TRAVEL REPORT

Code : D-1530A Date: August 2, 1983  
To : Chief, Division of Research  
From : Henry T. Falvey  
Subject: Review of TVA Intake Gate Closure Studies

REVIEW OF THE  
TENNESSEE VALLEY AUTHORITY  
INTAKE BULKHEAD GATE CLOSURE STUDIES

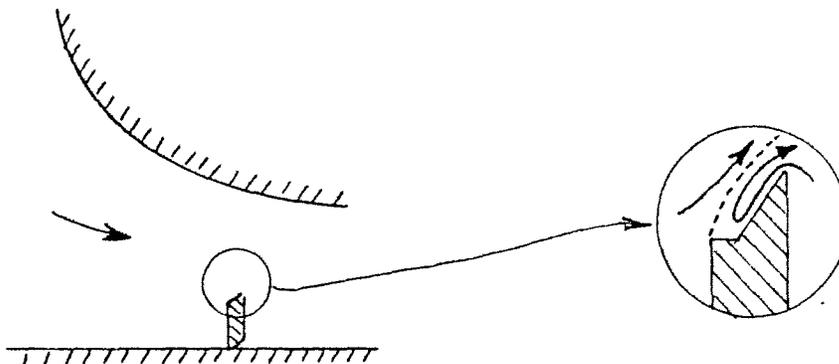
Similar measurements could be made in the prototype. The normal force in the prototype can probably be inferred by scaling up the model values. A direct measurement would be better; however, the cost is probably prohibitive.

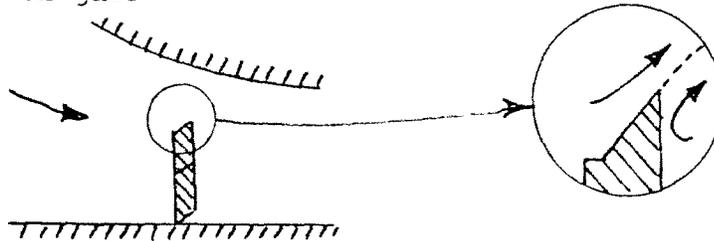
Approach flow conditions. - The flow lines were observed to separate from the leading edge of the lowest installed gate

With two gates installed, the separation was from the downstream edge of the gate

This effect could probably be best investigated using boundary element computations. The gate motion can be assumed to be slow enough to approximate quasi-steady state conditions.
